COMMENT AND RESPONSE DOCUMENT

Regarding Adoption of Air Quality Regulations Concerning Nitrogen Oxides (NOx) emissions

Date of Hearing: June 8, 2016

Figure 1-Relative contribution of source emissions to Fairfield, CT ozone monitor

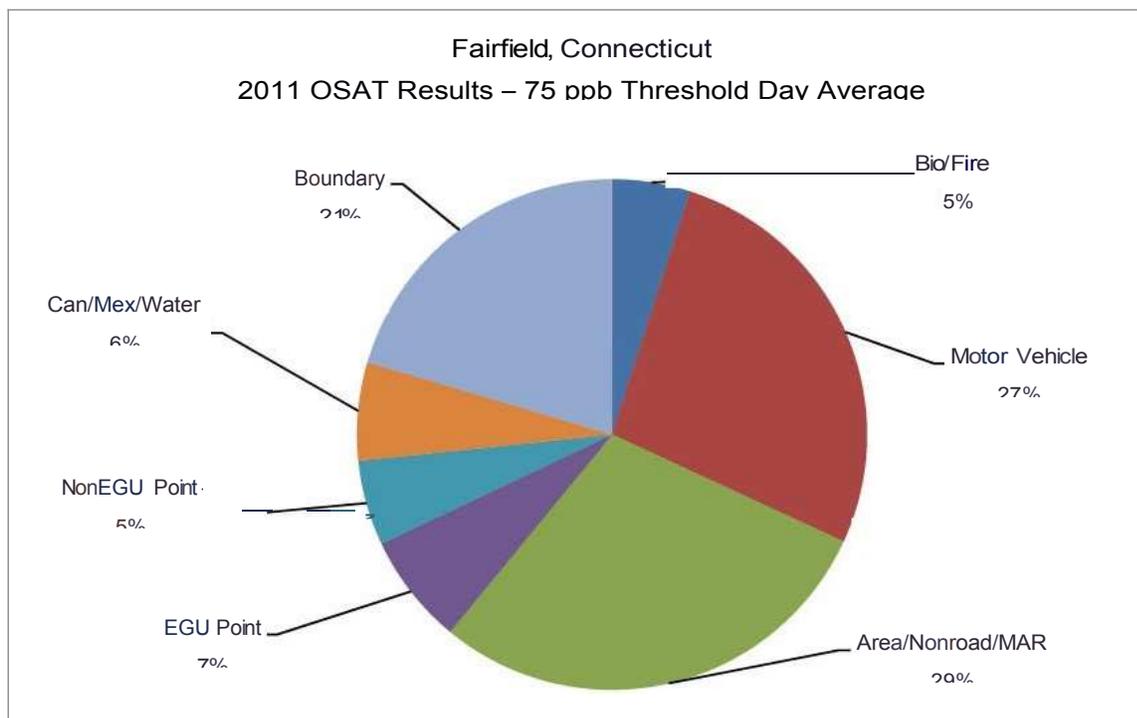
The commenter’s regional modeling analysis, conducted by Alpine Geophysics⁷ in June 2016 and summarized in Figure 1 reveals that ratcheting down the allowable emissions, up to and including forcing full shutdown of all of NRG’s EGUs, would have very little effect on overall air quality in Connecticut. The general basis for the analysis performed by Alpine Geophysics could be expanded to other EGUs in evaluating the overall actual impact that compliance with the new RCSA section 22a-174-22e would have.

As the Alpine Geophysics modeling report demonstrates, there would be very little impact made by prescriptive emission reductions aimed at the EGUs. Based upon this analysis and the fact that forced emission reductions do not actually result in an overall improvement in air quality, there is also a significant downside to this regulation as proposed which should be taken into consideration. A few examples of the potential negative impacts that the new Section 22e could have are:

DEEP agrees that transported air pollution continues to have a significant impact on Connecticut's air quality. However, Connecticut is required by sections 182(a) and (b) and 184(b) of the CAA to adopt and update RACT-based emissions limitations for all major sources of NO_x with the promulgation of a revised ozone NAAQS. *There is no emission reduction or ozone concentration reduction requirement associated with the implementation of RACT.* Connecticut's current RACT emissions limitations in RCSA section 22a-174-22 have been in place for over 20 years. New Jersey revised its NO_x RACT regulations in 2009 and NY revised its NO_x RACT regulations in 2010 in order to address the RACT requirement for the 2008 ozone National Ambient Air Quality Standard (NAAQS). Connecticut lags behind the other states with which it shares a moderate nonattainment area under the 2008 ozone NAAQS (the result of a June 2016 "bump-up" in nonattainment classification by EPA¹⁰) in terms of updating NO_x RACT requirements, and a number of the emission limitations, including those set out for EGU boilers in RCSA section 22a-174-22, no longer represent a RACT level of control.

Figure 2 □ July 11, 2011 CEM NOx emission comparison by contributing State (with NRG CT breakout).

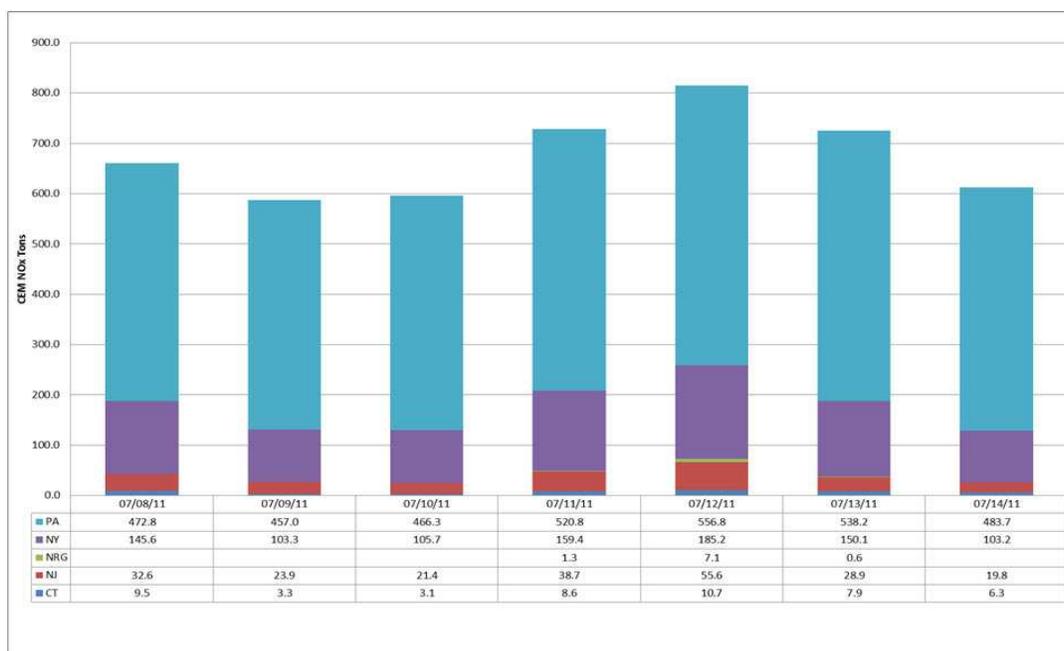
Additionally, in support of this, as can be seen in Figure 2 and from the Alpine Geophysics modeling analysis²⁰, the seasonal and HEDD daily impacts from NRG EGUs to Connecticut monitors are insignificant. Even if we were to remove all the EGUs emissions from the system there would be no impact on the state’s ozone attainment status. Therefore, NRG believes that potential hours should be replaced with actual hours in the case-by-case RACT determination.

As stated in DEEP's Response to Written Comment 37, NRG, should NRG wish to apply for a case-by-case RACT determination for an emission unit, NRG may indeed use the historical actual emissions, if NRG is willing to accept an enforceable restriction on emissions for such
